Reply to Comment on egusphere-2025-5836 by Anonymous Referee #1

Referee comment on "Improved NO₂ spectral fits for TROPOMI and OMI by removing wavelengths around 430 nm" by Jos van Geffen et al., <https://doi.org/10.5194/egusphere-2025-5836-RC1>

Referee comment on "Improved NO₂ spectral fits for TROPOMI and OMI by removing wavelengths around 430 nm" by Jos van Geffen et al., <https://doi.org/10.5194/egusphere-2025-5836-RC2>

Fig.RC 1: Example plots of the runs test variables R_D (top row) and R_L (bottom row) using a colour scale between values considered to be tell-tale signs of possible problems (left column) and a black-and-white separation of the regimes (right column).

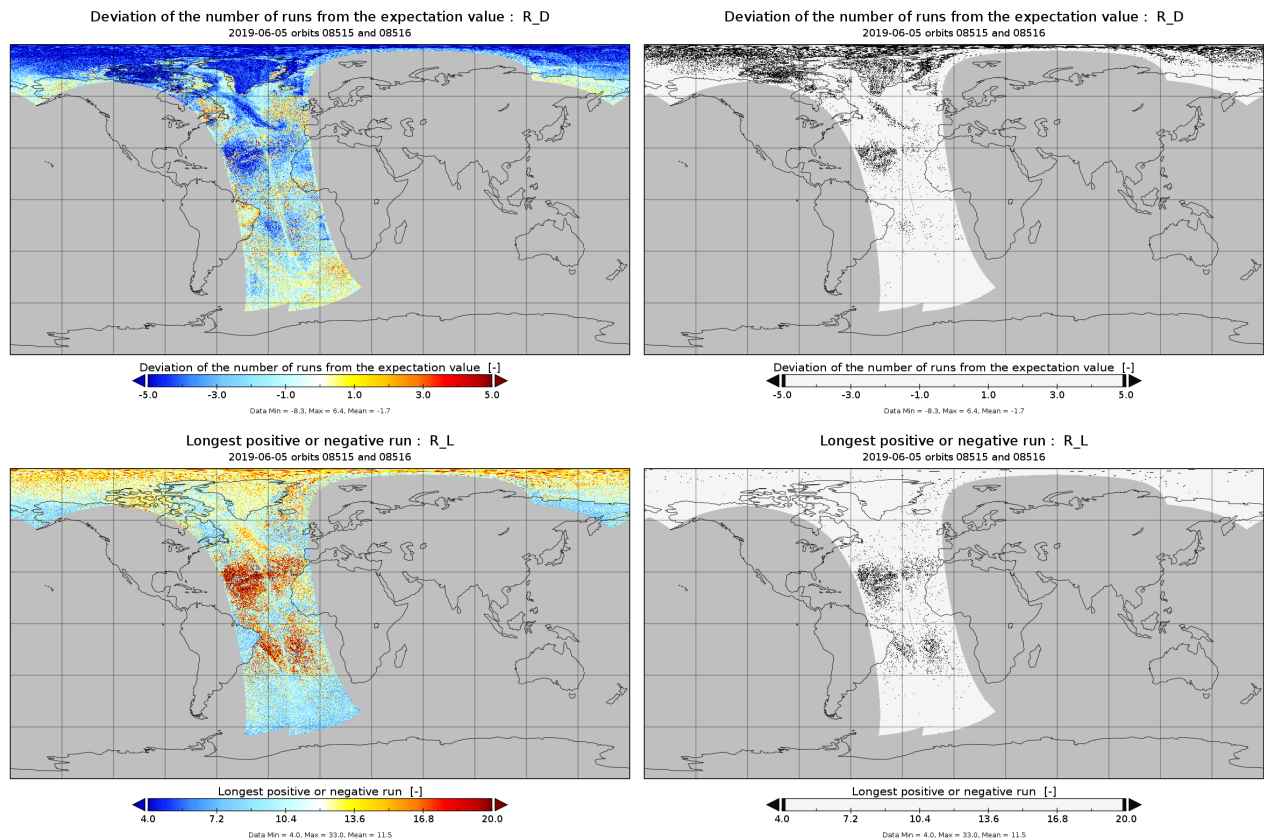
P9 Please include a global map of RD and RL

⇒ Such maps do not provide much information: depending on the scale used, they show a

scatter of many points or hardly any points. Fig.RC 1 above gives an example using two orbits. Obviously, one could select boundaries between the regions other than $|R_D| > 5$ and $R_L > 20$ to indicate possible problems. As the text of Sect. 2.2.3 stresses both R_D and R_L are *additional independent* sources of information on possible problems with retrieval results: they do not on their own signal problems.

Fig.RC 2: Scatter plots of the RMS_430 ratio (y-axis) as function of the solar zenith angle (top row) and viewing zenith angle (bottom row) for clear-sky pixels (left column) and cloudy pixels (right column) for the Atlantic Ocean orbit section of Sect. 3.1.

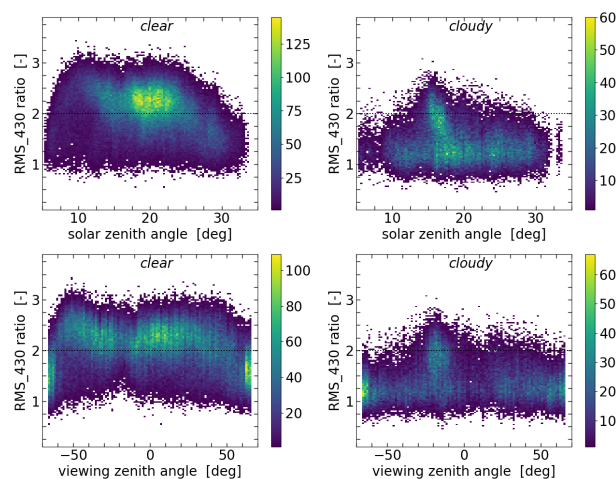
A possible dependence of the RMS_430 ratio on the viewing/scattering geometry is not really discussed in the manuscript. It would be useful to include scatter plots of the RMS_430 ratio as a function of solar-, viewing or scattering angles for clear-sky pixels over the Atlantic Ocean.

⇒ There is no apparent relationship between the RMS_430 ratio and SZA or VZA, as Fig.RC 2 shows (VZA values for the left side of the track are shown as negative angles); a remark to this effect is added to the end of Sect. 3.1. (The "peak" in RMS_430 around SZA $\approx 15^\circ$ and VZA $\approx 15^\circ$ are related to a cloud complex in the Atlantic Ocean orbit section.)

Fig_RC 1: Scatter plot of the RMS error as function of the cloud radiance fraction for the Atlantic Ocean section.

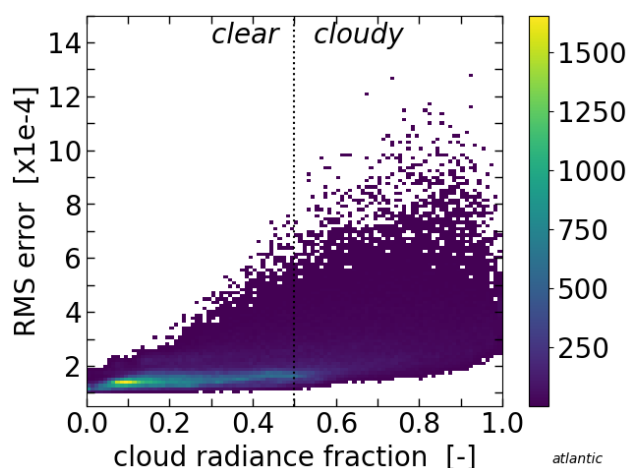
Here, I would expect the RMS to be smaller over cloudy pixels, due to the increased S/N ratio over bright scenes (more photons being reflected to the satellite). Maybe the reason for the low RMS_430 ratio is simply that water is hidden by clouds. Please clarify.

⇒ Fig_RC 1 shows the RMS error as function of the cloud radiance fraction for the Atlantic Ocean section of Sect. 3.1: although there is indeed more light over cloudy scenes (and thus the SNR is higher there), the fit residual is (much) more noisy over cloudy scenes. The text at the end of Sect. 3.1 has been updated to mention this.
